MEMORANDUM FOR: Docket No. 40-8783

SUBJECT: SAFETY EVALUATION REPORT FOR URANERZ U.S.A., INC., THE  
RUTH ISLE PROJECT

SAFETY EVALUATION REPORT  
SOURCE AND BYPRODUCT MATERIAL LICENSE  
URANERZ U.S.A., INC.  
RUTH ISL PROJECT  
JOHNSON COUNTY, WYOMING  
DOCKET NO. 40-8783  
LICENSE NO. SUA-1401  
OCTOBER 28, 1981

Figure 3C

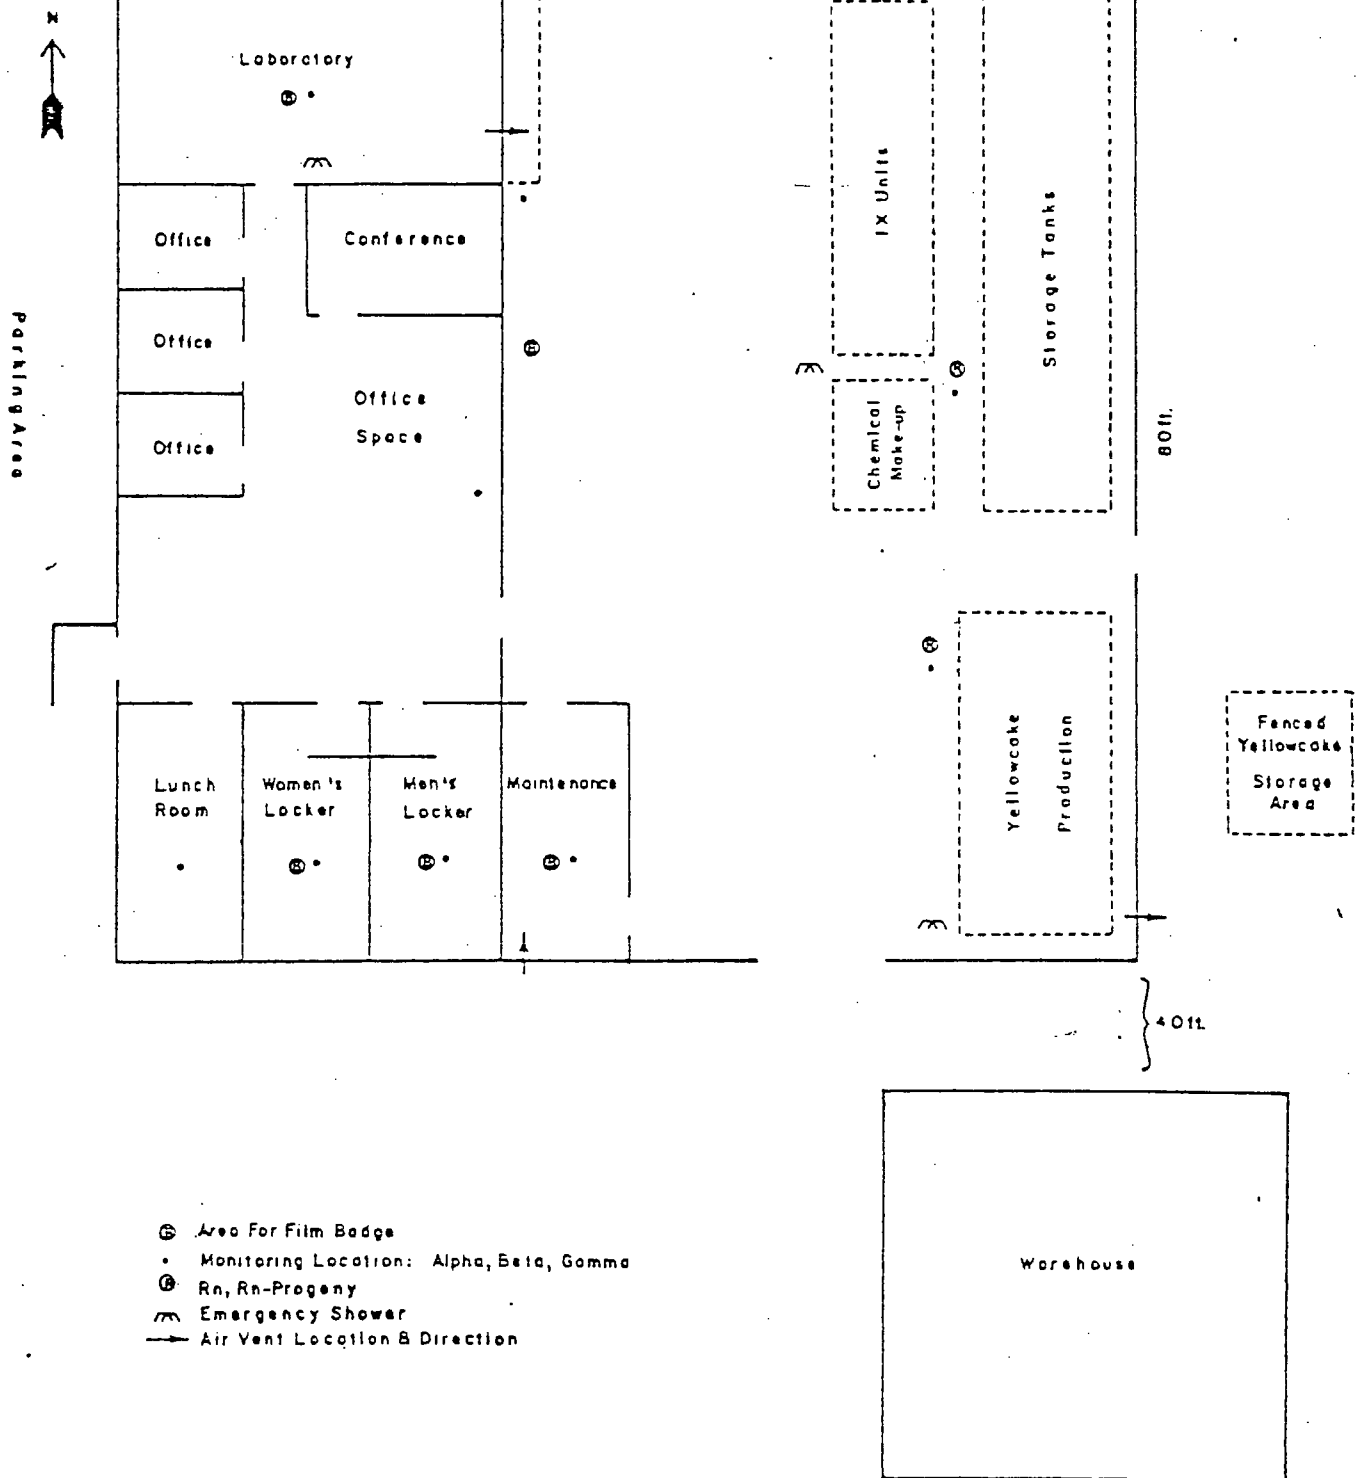
The applicant provided a facility floor diagram as indicated in Figure 30 to the application dated November 25, 1980, as revised September 1, 1981, showing the proposed layout for the process area; offices, the laboratory, and worker change and eating areas. The proposed layout is acceptable.

Figure 31  
Revised 10/8/81

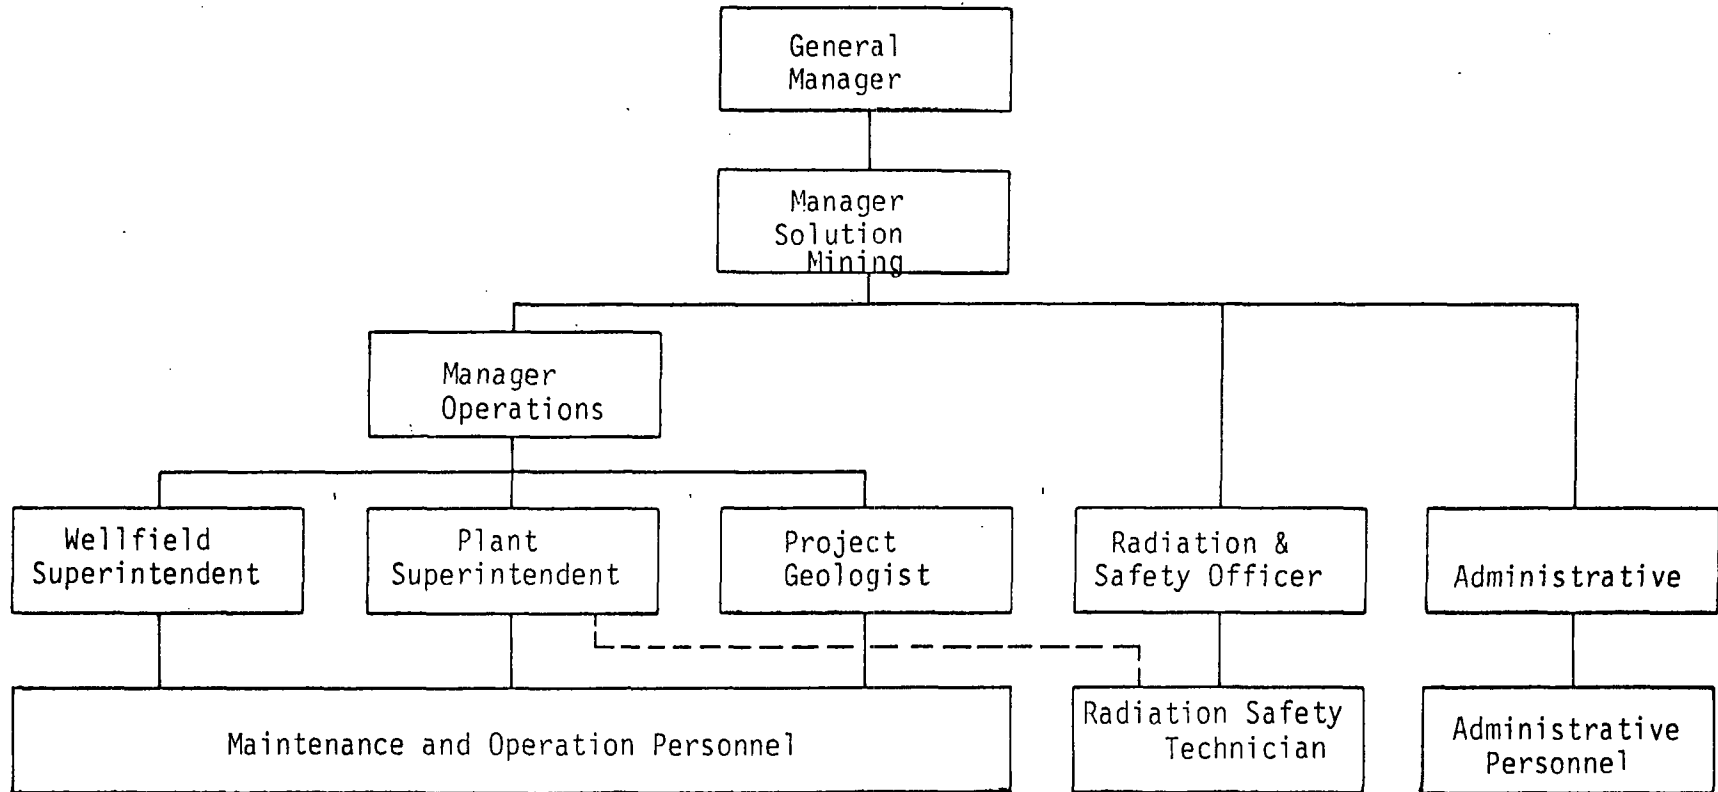
The staff has concluded that the proposed management organization is acceptable. The minimum qualifications of the site RST are presented later in the section. The staff recommends, but does not require, that the RST should not be assigned other production-related duties. The RST shall supervise any additional radiation safety staff assigned to the site. The RST may have other safety-related duties, such as responsibility for programs of industrial hygiene and fire safety.
